Access Review

St Anthony of Padua Catholic
School Austral, Masterplan

Report Issue 2

05/06/19

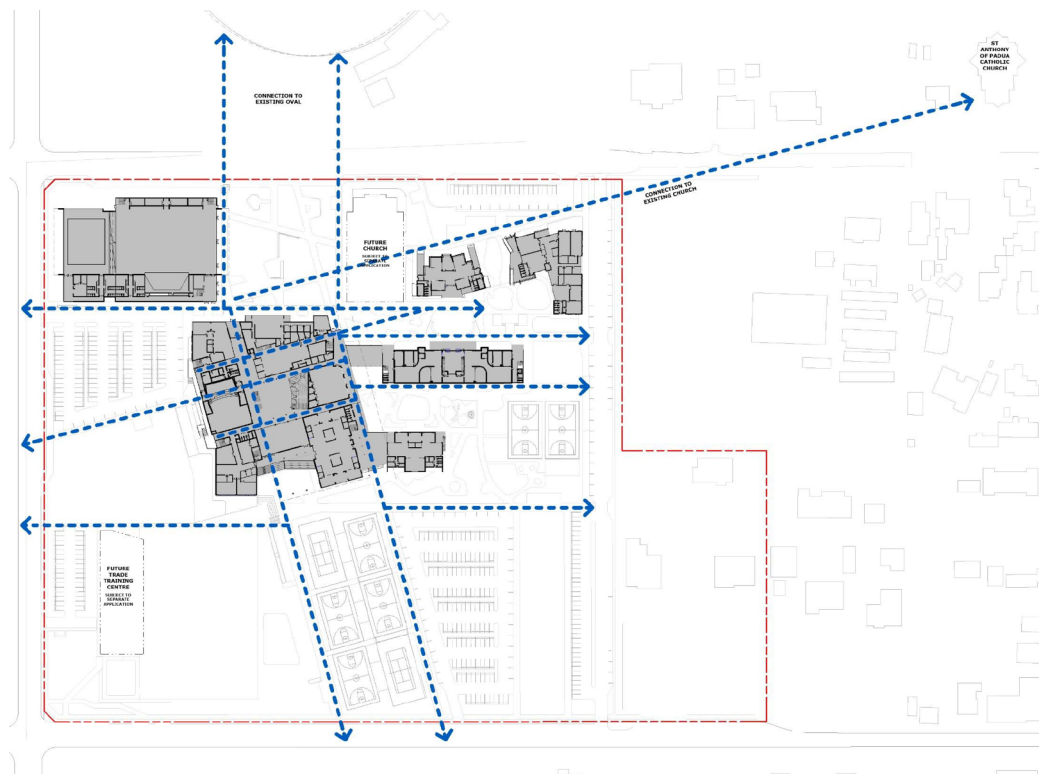
The following diagram shows the proposed provision of continuous accessible paths of travel through the school and linking all facilities and buildings. Four lifts are proposed in the hub building in the following areas:

- performing arts / engineering / science
- reception and administration
- entry foyer adjacent sacred space
- year 1 / year 2

A continuous accessible path of travel is an uninterrupted route to and within premises providing access to all features, services and facilities. It is any step free and safe. A continuous accessible path of travel should extend to all amenities and areas to which the public (including employees) is entitled or allowed to enter or use.

A continuous accessible path of travel should be the most commonly used and direct path of travel. If for any reason this is not possible, clear signage of the alternative route should be provided.
